BULLETIN NO. 415-SE-07 Rev. A

APPLICABLE TO: 415SE DME (098739-0001)

**SUBJECT:** This service bulletin is for wiring information if an optic coupler needs replaced. There are no defects with the existing optic coupler. Thales has found the optical coupler part # 046C05-0002 is now obsolete. It has been replaced with Thales part # 046C05-0005. The optical coupler is used to slave the 415 SE DME to the ILS ident.

Wiring connection for obsolete 046C05-0002 optic coupler

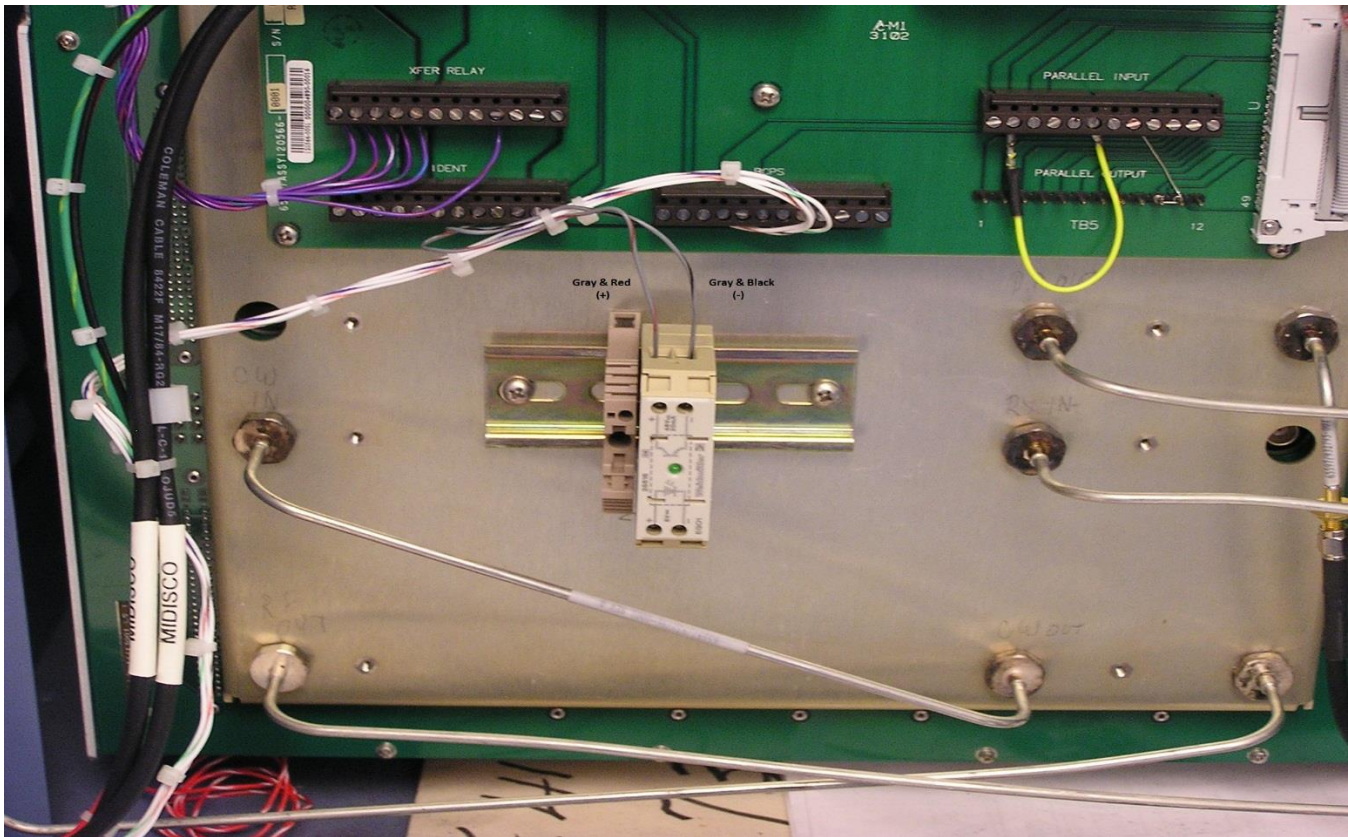
**ISSUE:** There is a difference between the labeling on the two optical couplers. This may be confusing on how to wire the replacement coupler. The two drawings below show both dash number optical couplers and how to connect the wiring.

Wiring connection for new 046C05-0005 optic coupler
